City of San Antonio

Re: Hills of Castle Rock

MDP # 043-06

The City Staff Development Review Committee has reviewed Hills of Castle Rock Master Development Plan **MDP # 043-06**. Please find enclosed a signed copy for your files. Your plan was approved for acceptance; however please note the following conditions:

MASTER DEVELOPMENT PLAN

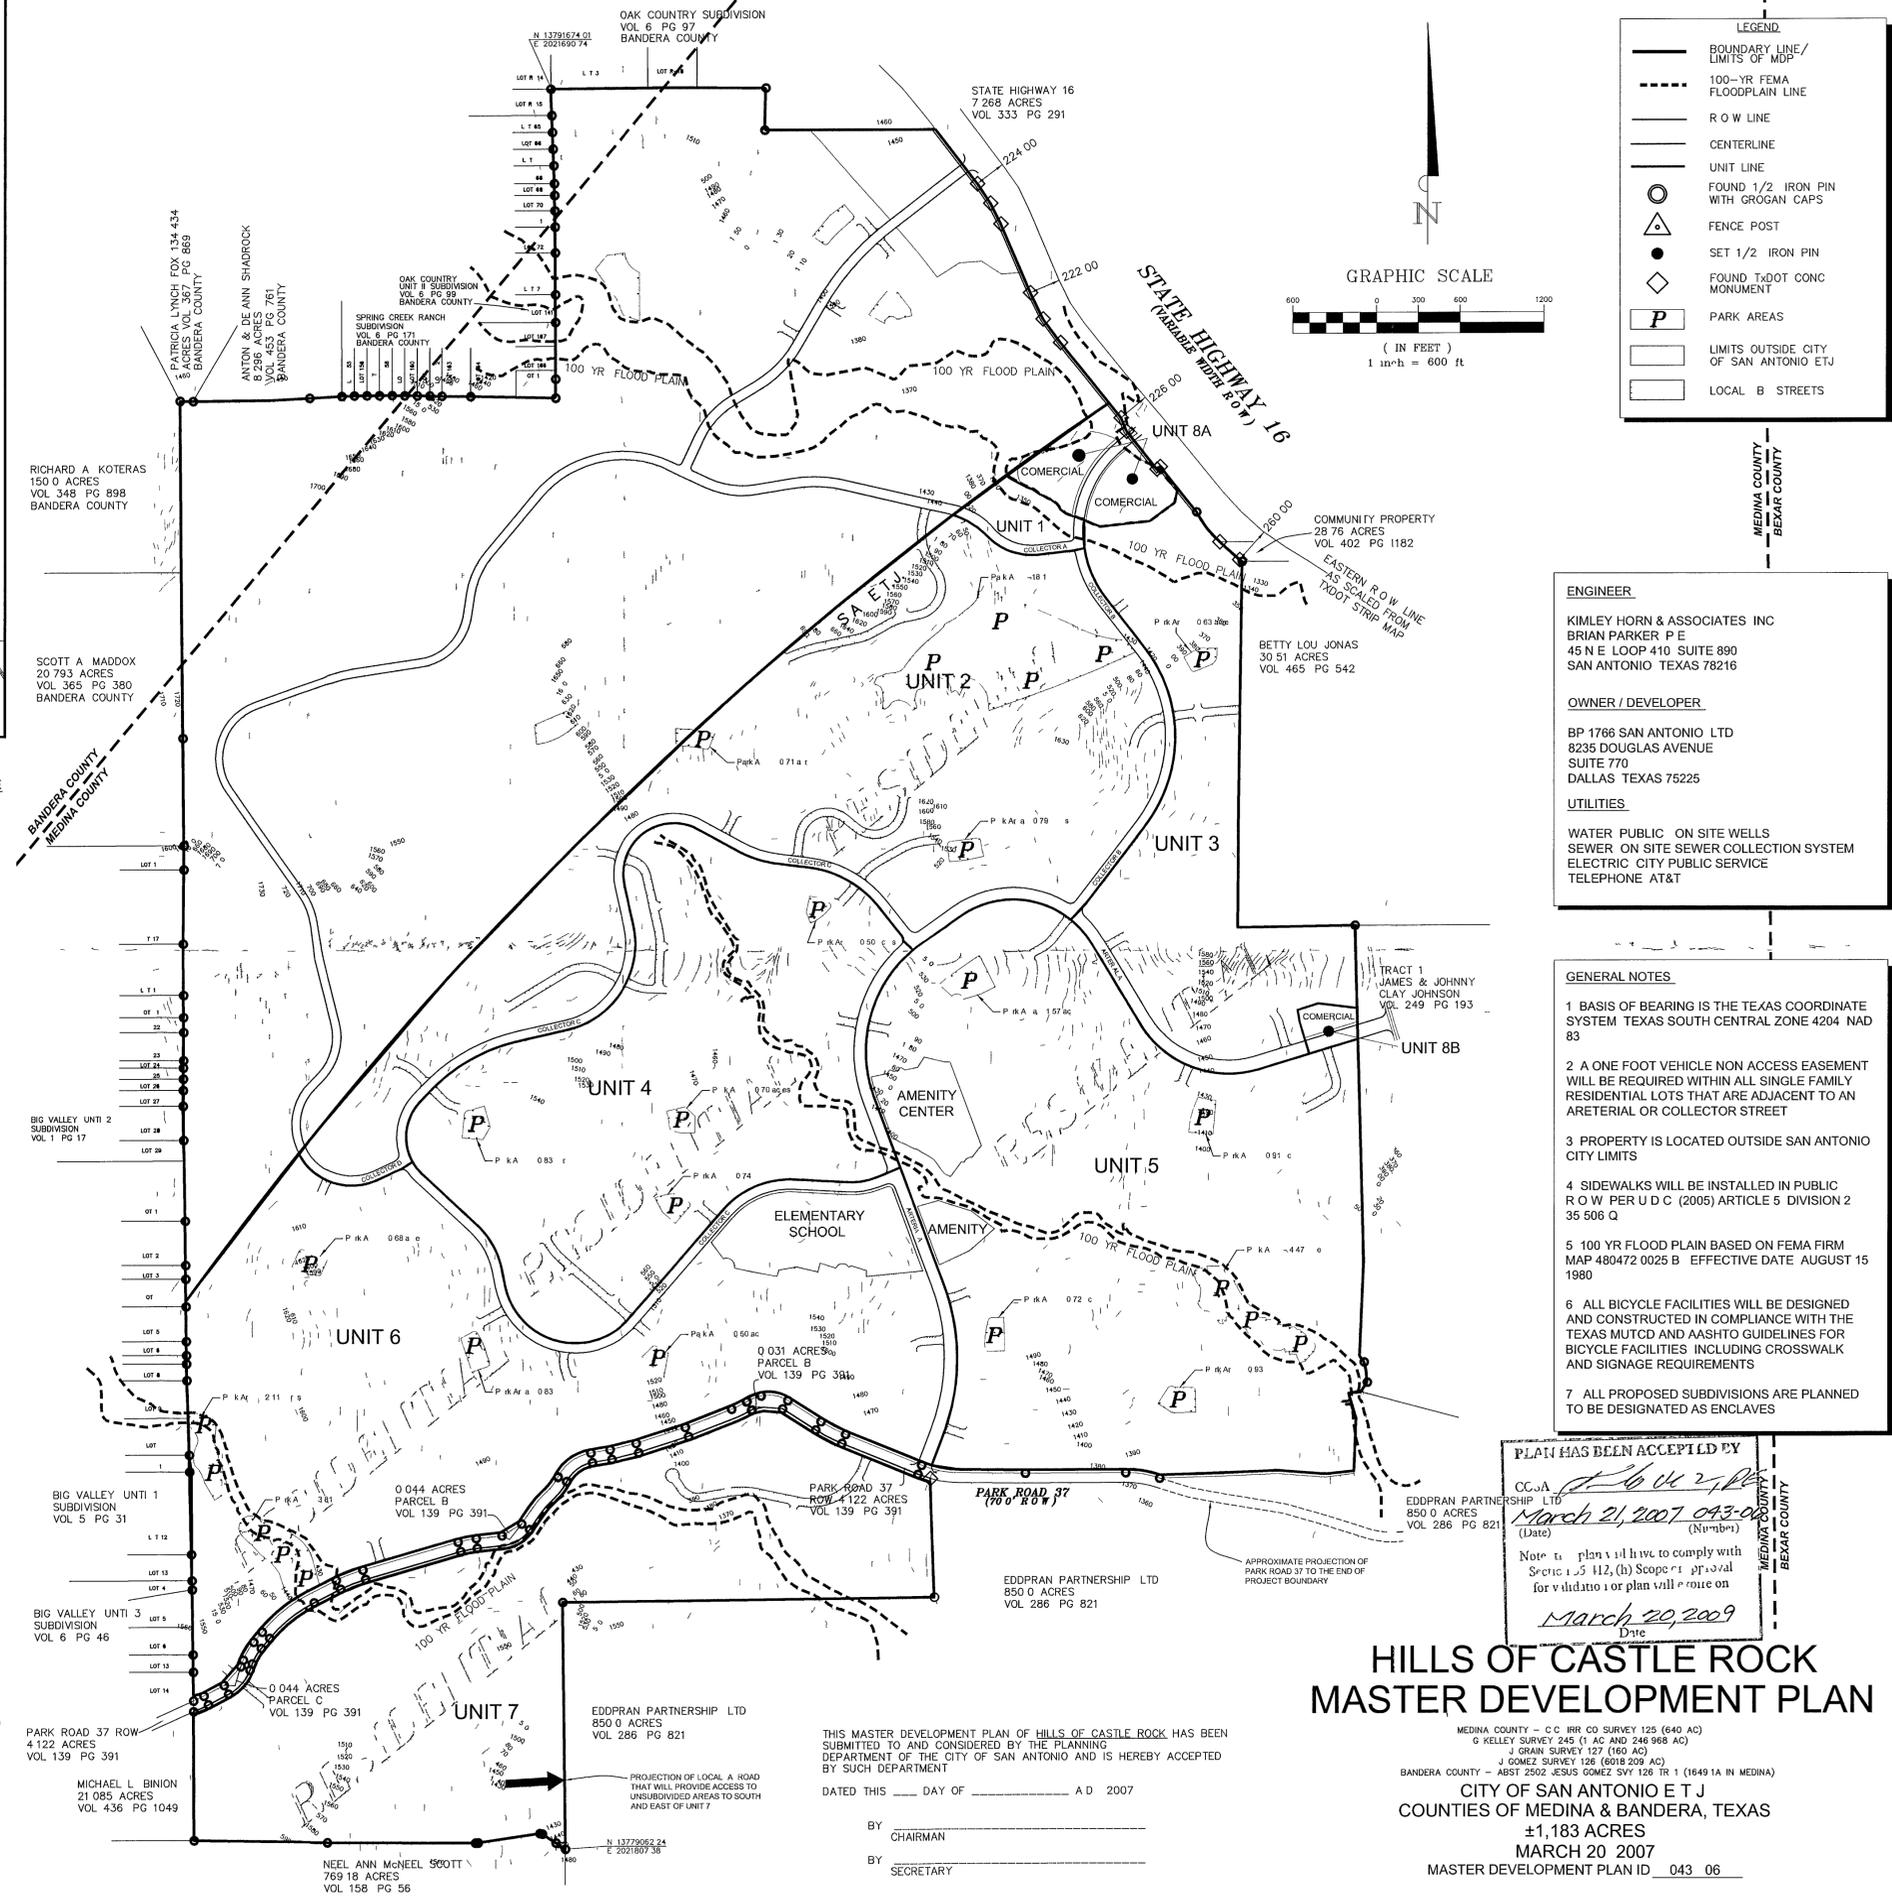
In consideration of public safety and convenience, excessive grades by reason of topography should be avoided in street layouts and arrangements. Any access and R.O.W. issues along state facilities will need to be resolved with the **Texas Department of Transportation (TXDOT)**. For information about these requirements you can contact TXDOT at 615-5814.

- All roadways shall follow Table 506-1, Functional Classification System Description and shall comply with UDC 35-502(a)(9).
- All access roadways shall provide clear sight distance on all existing and proposed roadways in order to provide adequate obstruction free viewing distances for approaching traffic. All signage, landscaping, and improvements shall not block these clear sight distance areas.
- Sidewalks along all interior and exterior roadways are to be installed in accordance with UDC 35-506(q).
- Secondary access must be secured prior to the approval of any plat or combination of plats exceeding 125 dwelling units.

- The developer shall be responsible for providing a left and right-turn deceleration lane at the various proposed entrances, with storage length and bay taper per TXDOT design standards as it relates to the submitted TIA traffic counts and table 6 of the TIA Report, (Unified Development Code (UDC) - 35-502 (a)(7), subsection C.

NOTE: Texas Department of Transportation (TXDOT) will determine the access point along SH 16 and the need of any traffic signal when warranted, coordination with TXDOT Traffic Section will be required.

- The parkland provided shall be shown as “Park” or “Open Space” on a plat; UDC section 35-503(e) *Designation of Parkland*.
- The parkland provided shall be dedicated to the Homeowners Association.
- The instruments creating the Homeowners Association shall be provided by the second application for plat approval; UDC section 35-503(e) *Designation of Parkland*
- Parkland dedication shall be platted by the second phase of development; UDC section 35-503(f) *Development Phasing*.
- Parkland provided shall conform to UDC section 35-503 (c)(3) Table 503-2 *Parks and Open Space*.
- Parkland provided shall conform to UDC section 35-503 (d)(7) *Access*.

- 2003 Tree Preservation ordinance standards per UDC Section 35-523 shall apply. A tree Preservation Plan is required prior to any work on site (35% preservation for residential and 40% preservation for commercial). This can be submitted either as a clearing permit or at the platting stage. This project appears to be suited to a Tree Stand Delineation (25% preservation of significant trees with understory intact and 100% preservation of heritage trees). Note that flood plain area must be delineated separately (preserved at 80% for significant trees and 100% for heritage trees).

- Streetscape standards per UDC Section 35-512 - The proposed Collector and Arterials rights-of-way will require streetscape planting (we recommend preservation of existing trees where available and possible).

The tree stand delineation submitted does include areas delineated as canopy that are actually open areas without trees and other areas of the site which are apparently canopied but are not delineated (canopy is identified as at least one protected-sized tree every 350 square feet of area). The MDP is being approved at this time, but it should be noted that the canopy delineation will need modification if this method is used for the preservation plan.
